Base Load Power Hub (BLPH)

90% 3D Model Review Report

Document Number: 123A90-DDL-PP-RE-70010

BLPH - 90% 3D MODEL REVIEW
ACTION ITEM REGISTER

MR90-TAG07

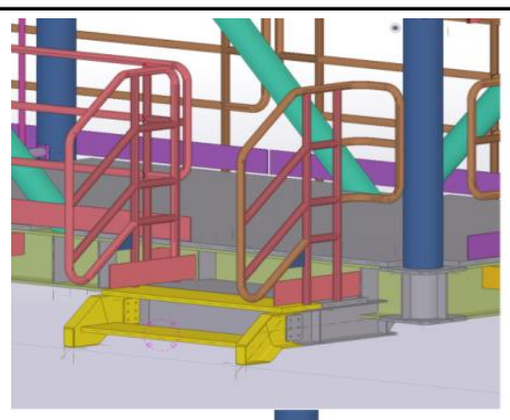
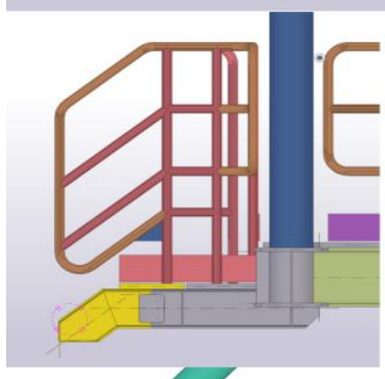
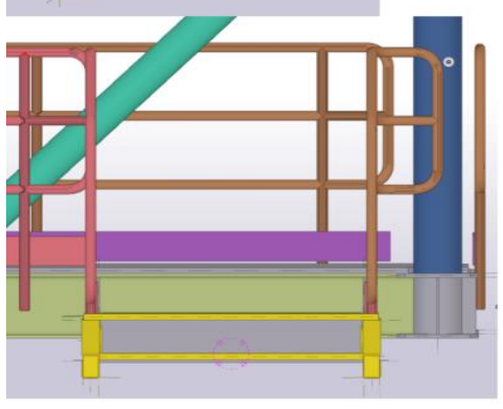
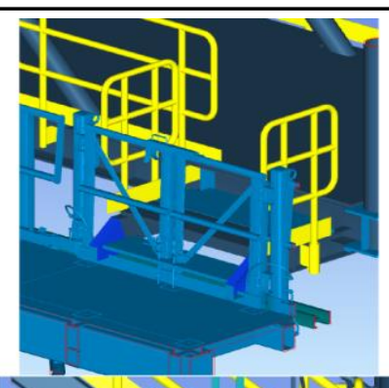
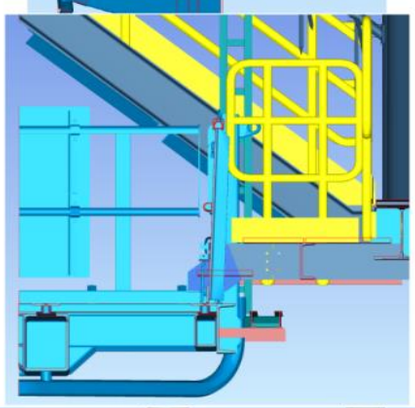
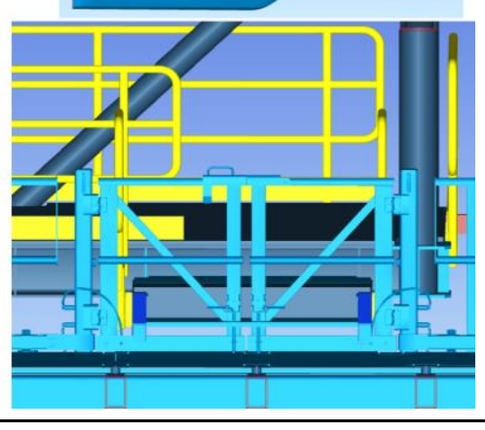
To check the correct dimension of the handrail with construction

removable handrail will be installed on portion of stair connected to TP. The final connection with MAP will be with bolted portion of stair offshore installed to avoid clash with MAP during TP set down. NOTE: gate to be opened before installation and removed once portion of ladder will be installed and bolted.

MR90-TAG08

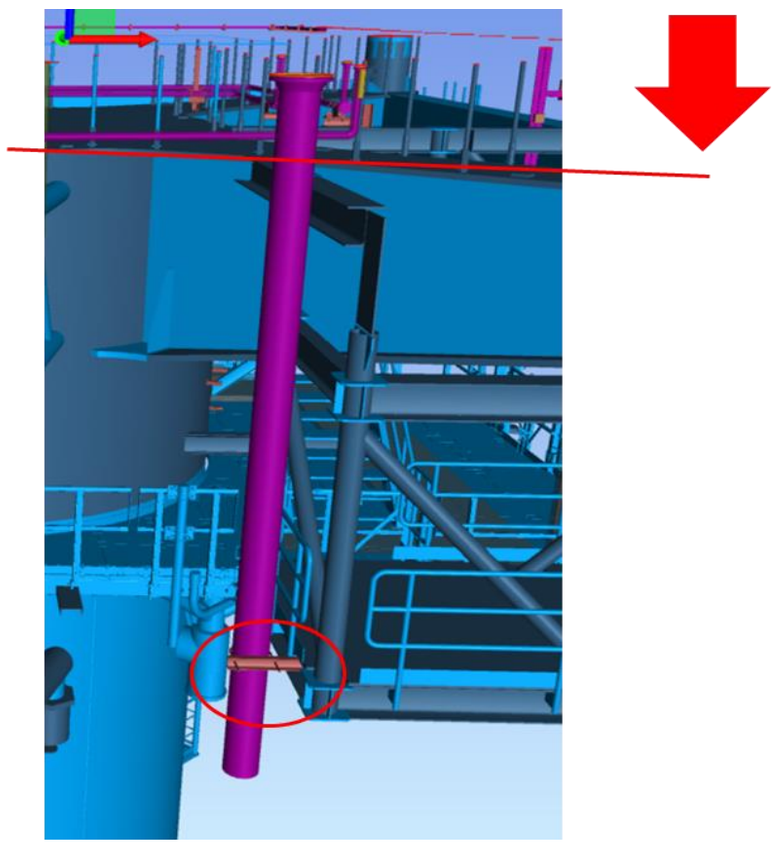
Installation of drain water to be checked

During transportation and installation drain pipe will be maintained in temporary position (lowered around 60cm from final position) by dedicated supports. After Topside installation, during hook up it will be liftet and flanged connection will be performed.

MR90-TAG09

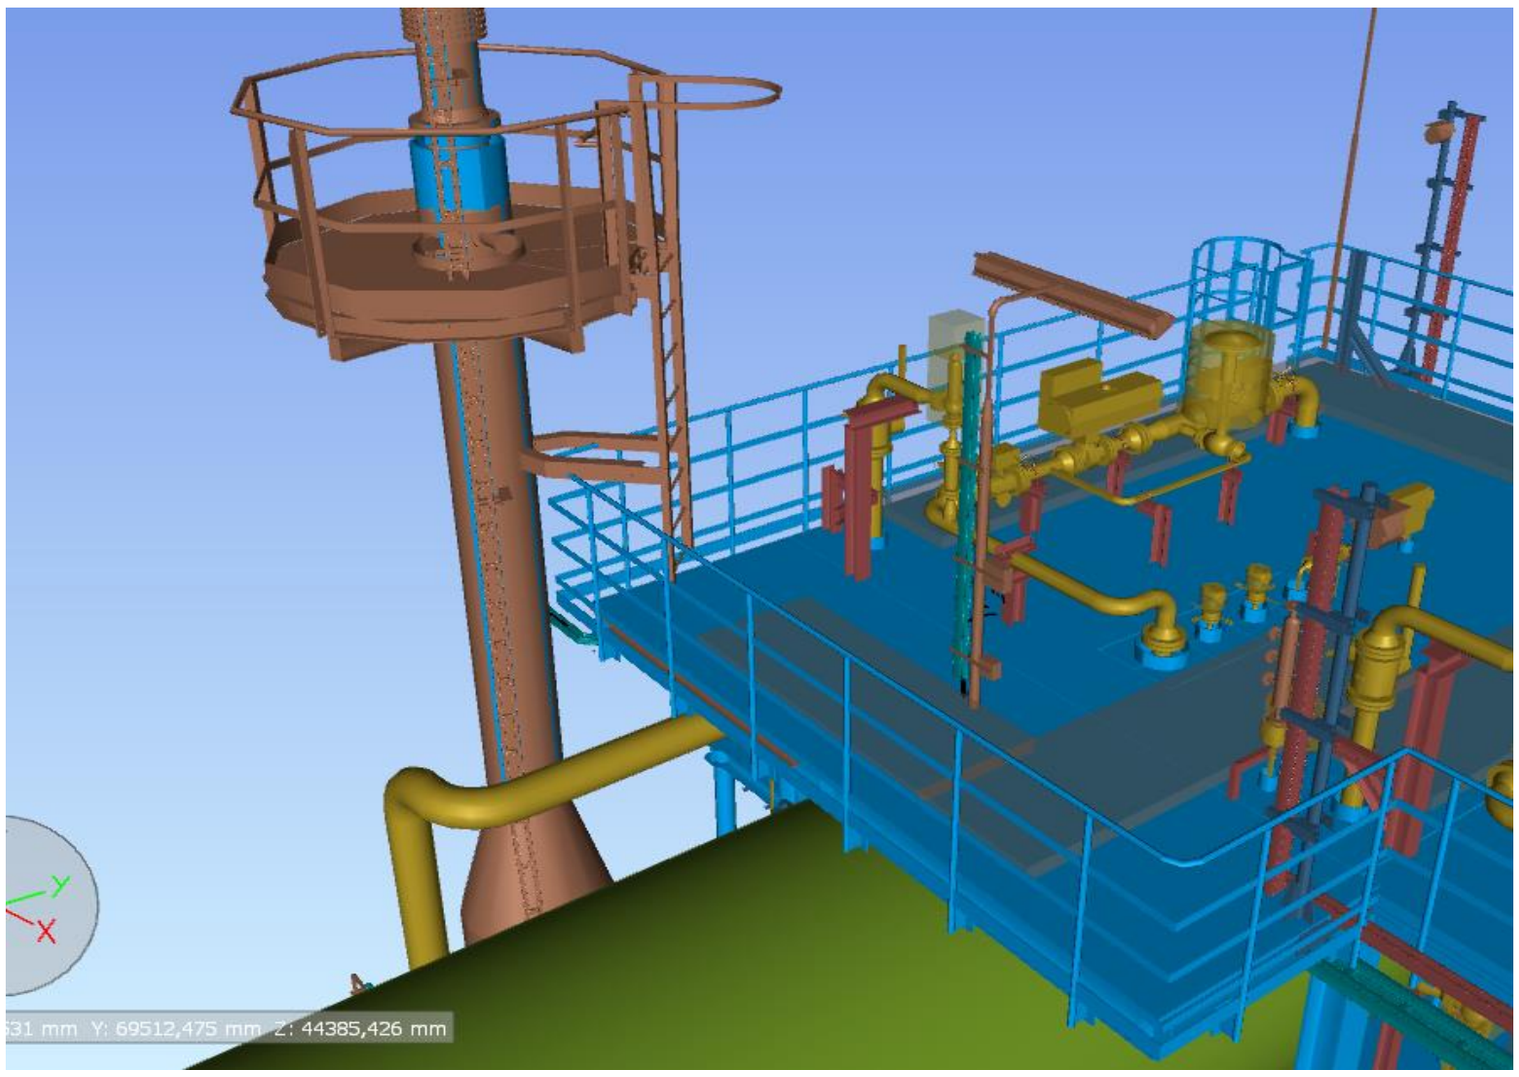
To provide installation and access platform for h2 vent

The platform and access ladder to the vent have been added.

MR90-TAG11

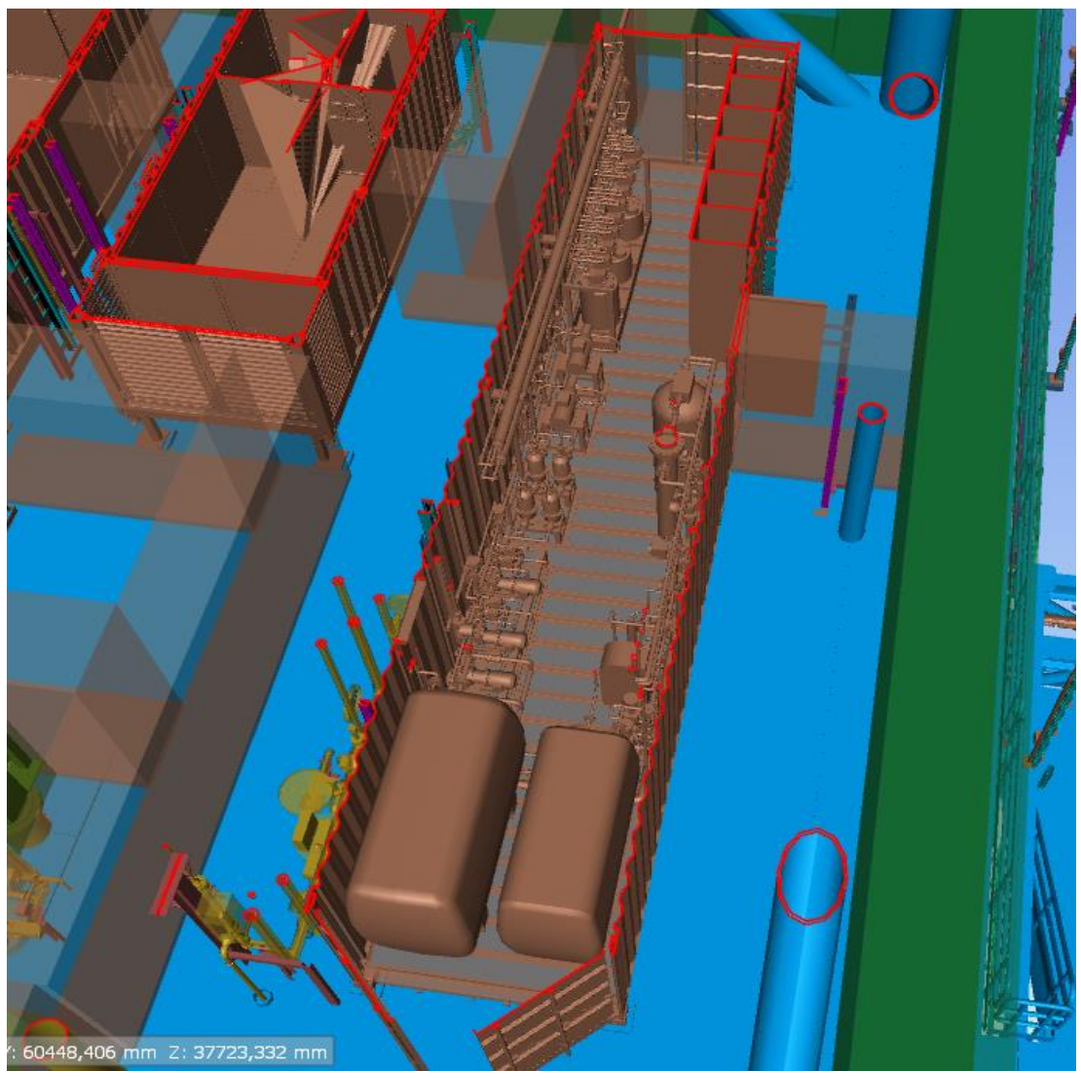
Internal water treatment to be completed

Internal water treatment has been completed.

MR90-TAG12

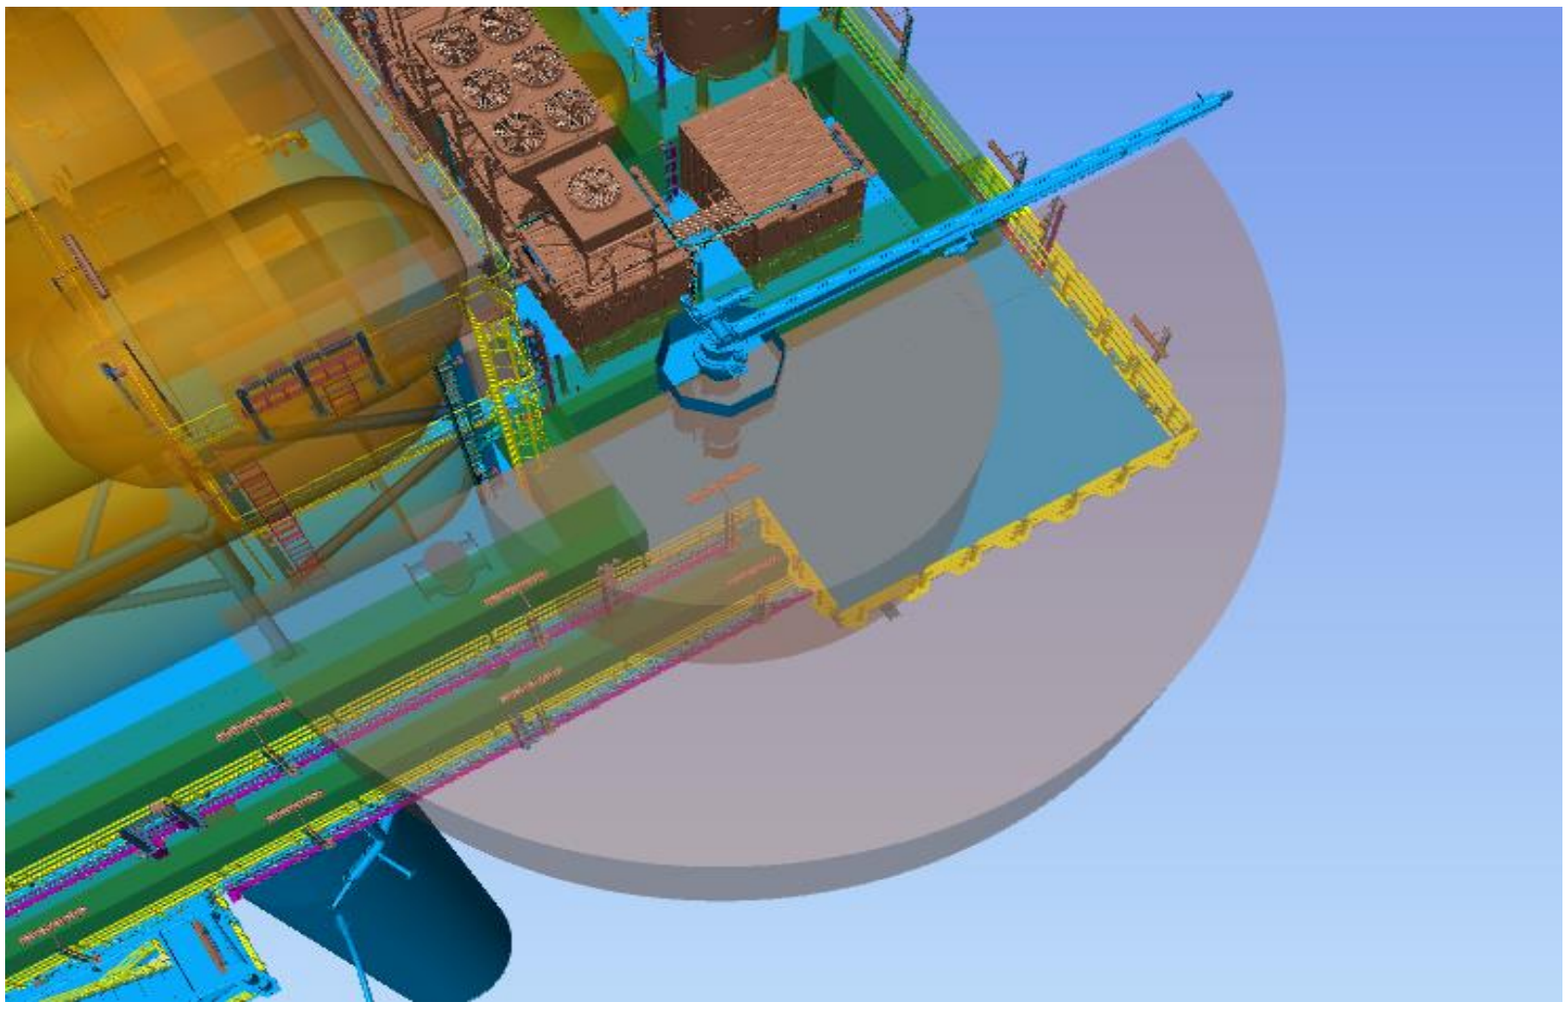
Envelope 180° (5m,10m)

The 180° envelope (5m, 10m) has been represented

MR90-TAG13

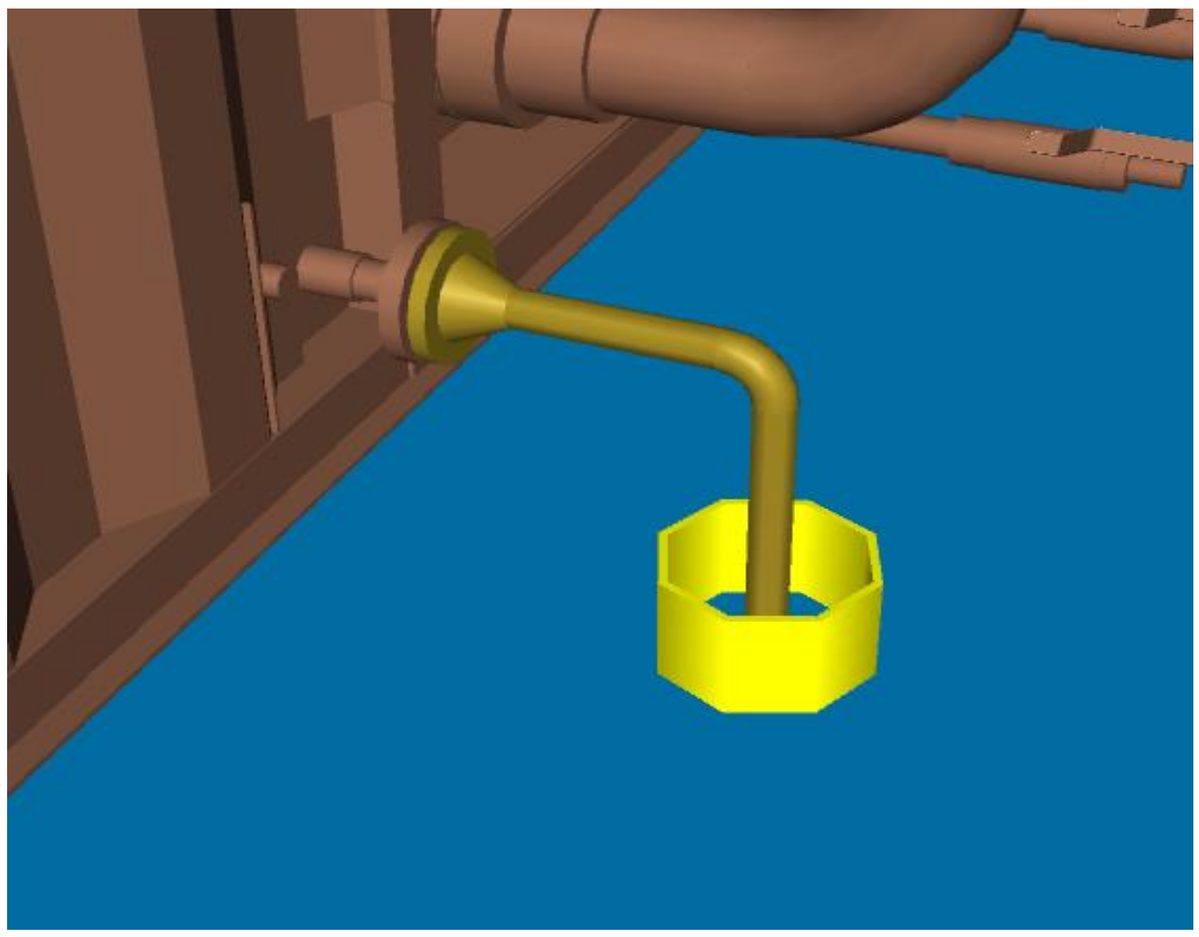
Check the drain connection on the fuel cell

The fuel cell drain has been connected

MR90-TAG14

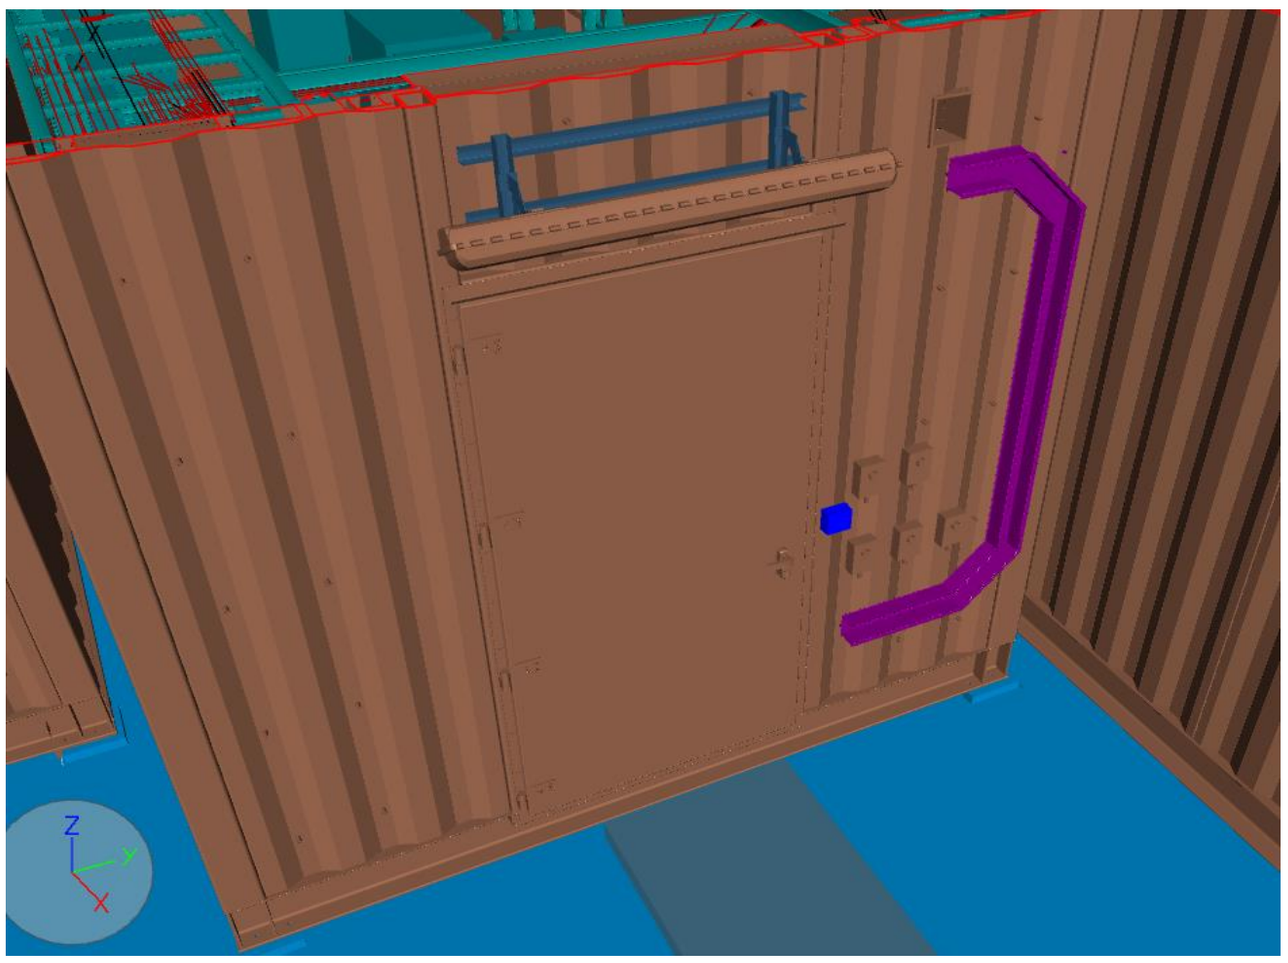
Lightswitch shall be moved in more accessible position

Lightswitch have been moved outer wall of the container as per the container vendor GA drawing

MR90-TAG15

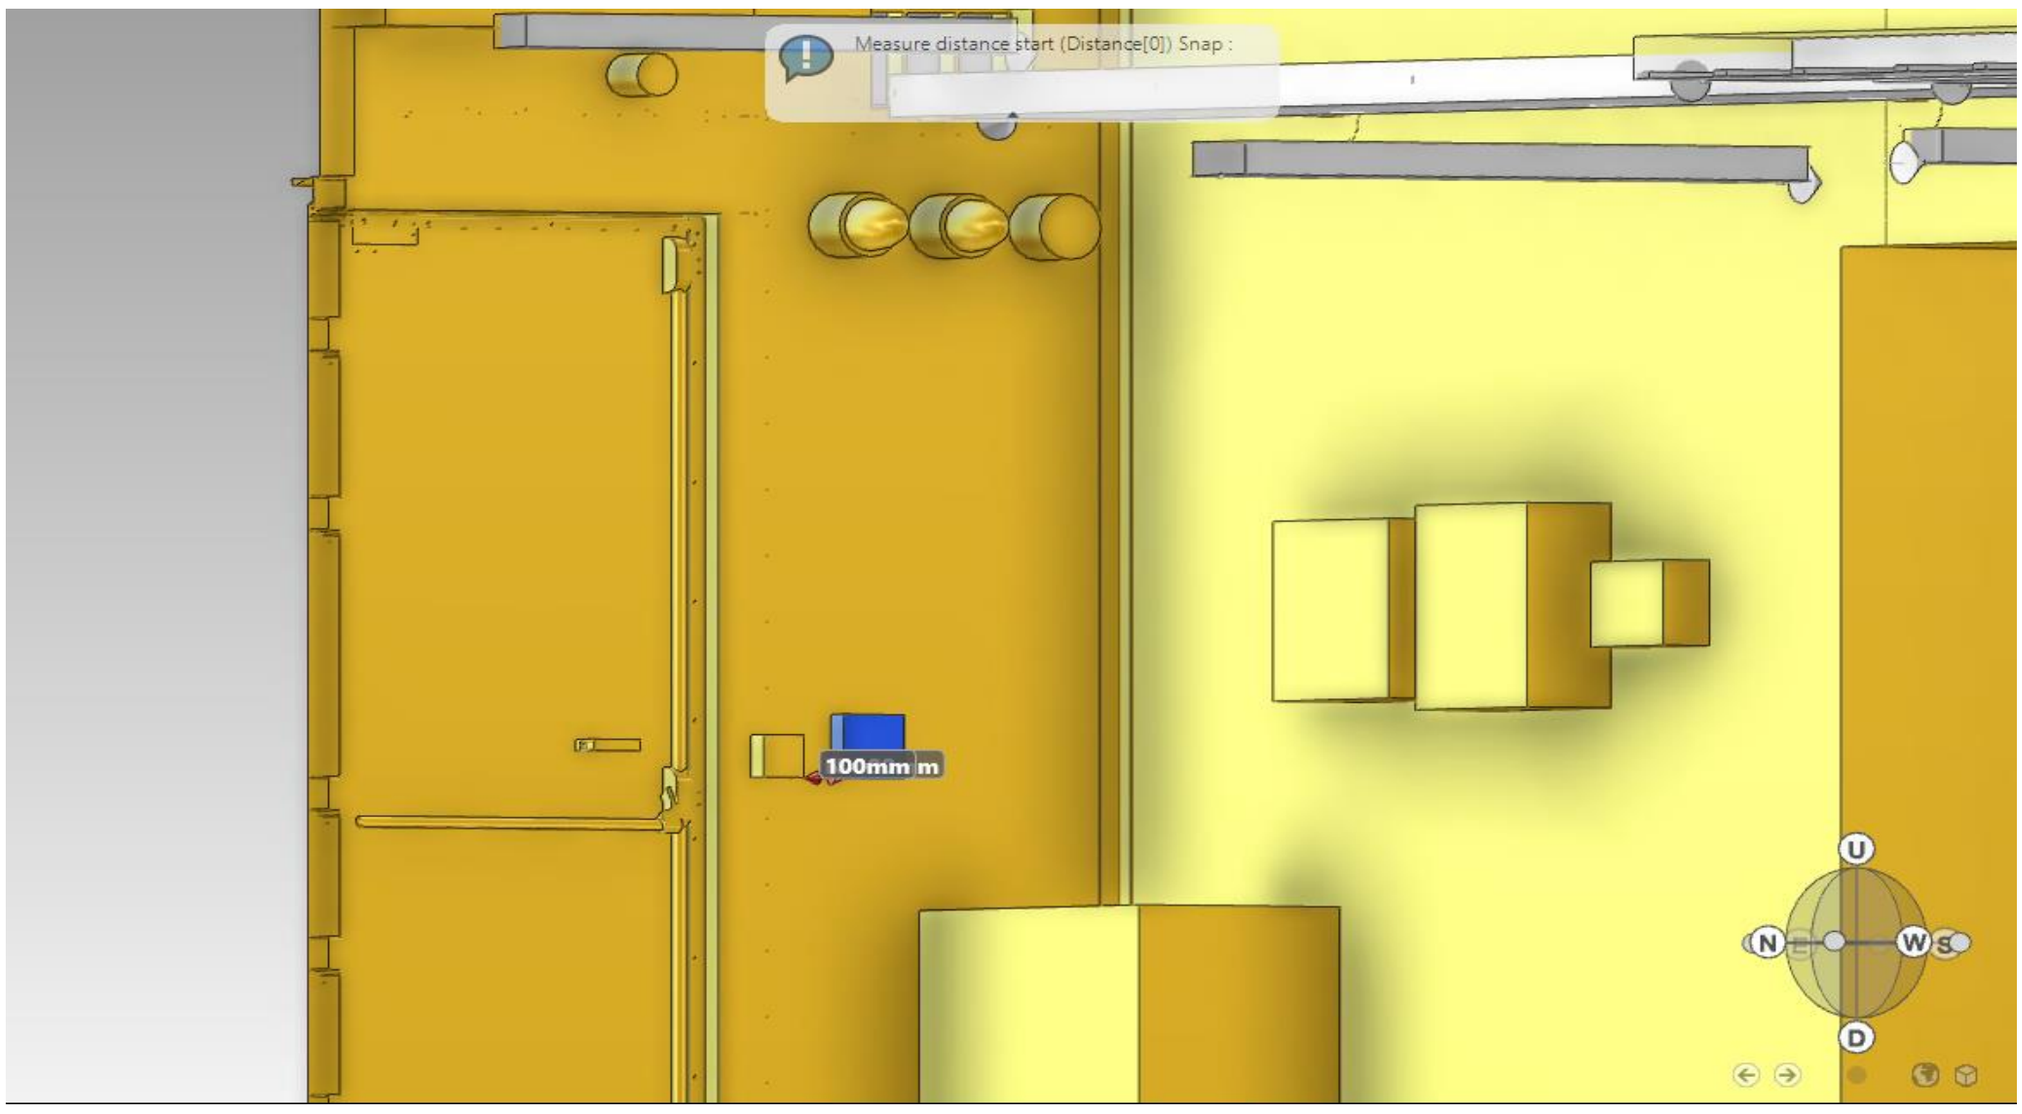
Sounders and beacons shall be moved on the left

Manual Call Point has been moved close to opposite door together to beacons and sounder for space missing.
